Committee of Experts on the Transport of Dangerous Goods and on the Globally Harmonized System of Classification and Labelling of Chemicals

Explosives and related matters: DDT Test and Criteria for flash composition

Editorial Corrections to paper ST/SG/AC.10/C.3/2012/30

Transmitted by the expert from the United States of America

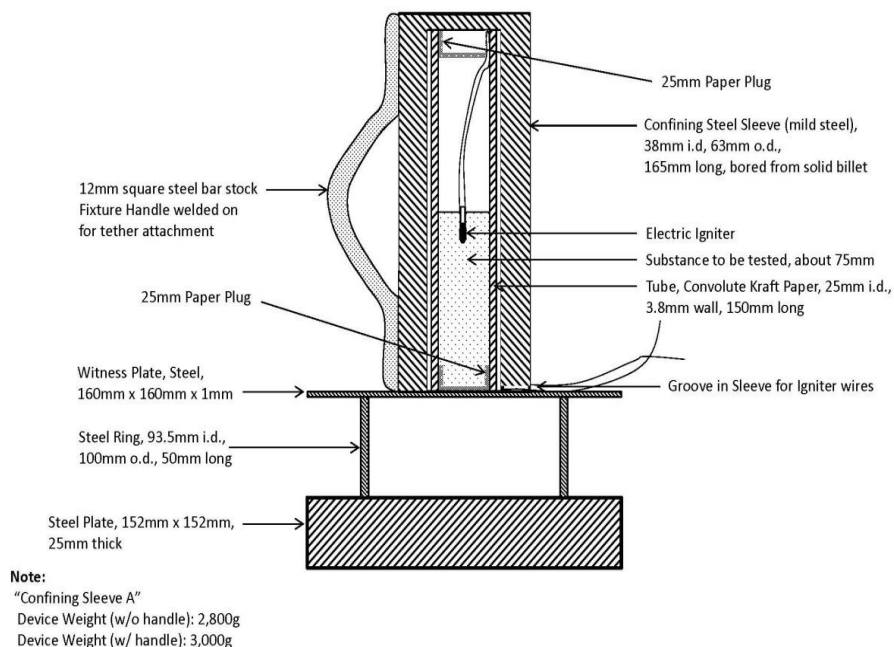
1. This paper makes two editorial amendments to ST/SG/AC.10/C3/2012/30 as follows:
2. Replace Figure 1 “Standard DDT test fixture” and Figure “YY” with the drawing below correcting the outer dimension of the steel sleeve:
